ADDENDUM NO. 02
TO
SPECIFICATIONS AND CONTRACT DOCUMENTS
FOR
INVITATION TO BID
TMT WAREHOUSE #1 RE-ROOF
JPA CONTRACT NO. C-1631A

Project Title:
TALLEYRAND MARINE TERMINAL WAREHOUSE #1 RE-ROOF DEMOLITION ROOF PLAN AND DETAIL

Project Title: **TALLEYRAND MARINE TERMINAL WAREHOUSE #1 RE-ROOF**
PROPOSED MODIFIED BIT ROOF DETAILS
 Date: SEPTEMBER 2021
 Proj. No.: EGXM2600
 Drawing No.: A-501

2 TYPICAL DEMOLITION EDGE CONDITION
SCALE: 3" = 1'-0"

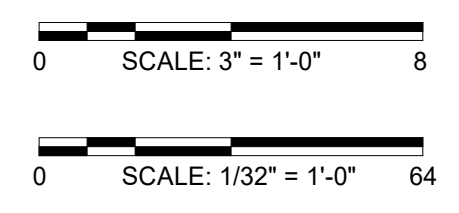
Reference Drawing Detail #2, Sheet AD-103 **DELETE** in its entirety and **REPLACE** with Drawing Detail #2, Sheet AD-103 and A-501.

18. Detail #2 on Sheet AD-103 requires the removal of the perimeter edge angle iron. Do we replace with new?

ANSWER: Yes, this will need to be replaced to conceal the roof edge. Refer to revised Sheet AD-103 and A-501 attached. (See Attachment Nos. 3 & 4)
